Reaction to the Public consultation

Task Force Princess Elisabeth Zone

January 2024

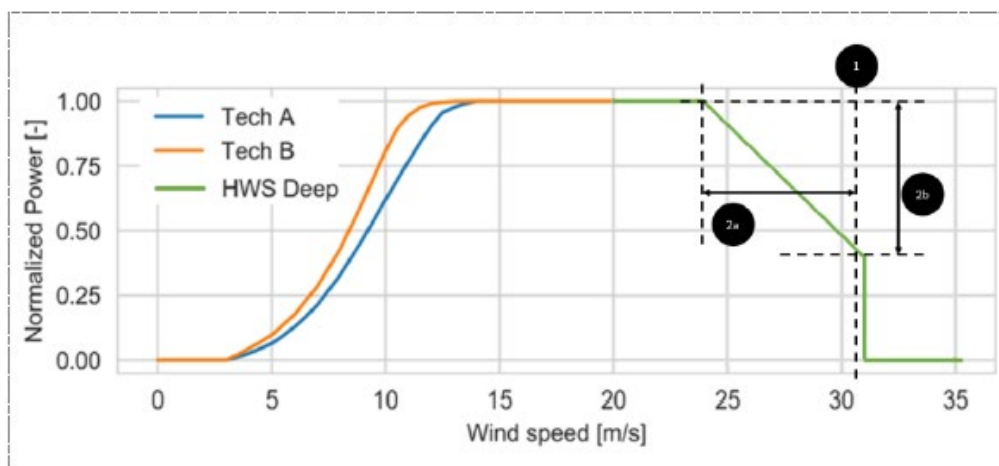
To avoid that a requirement for a certain technology or set of specifications, would disproportionately influence the turbine-decision and thus drive-up prices, **we request that the specifications are kept sufficiently broad, and focus on the downward slope of the power curve but do not prescribe the exact cut-off wind speed.** Allowing a mixture in the PEZ of both 'moderate' and 'deep' HWS (as defined in the Public Consultation Report) should actually rather be seen as a benefit from a grid perspective, as it smoothens how the total PEZ capacity reacts in case of a storm, further spreading out – in time – a potential full shut-down.

We therefore suggest that the technical requirements should be limited to the prescription of the downward slope, as follows (section 5.7.1.1 of the Report), but without the specification of the minimal sudden cut-off speed⁷ (1 in the figure below) :

A sudden cut-off with an instantaneous reduction of the wind power injection from full capacity to 0 MW will not be accepted and a minimum slope of power decrease will be requested with:

- a. *gradual power decrease starting at an average wind speed at least 5m/sec below the sudden cut-out average wind speed (2a in the figure below);*

- b. gradual decrease of power must be guaranteed until a Nominal Power of at least 0.5 before sudden cut-out occurs (2b in the figure below).
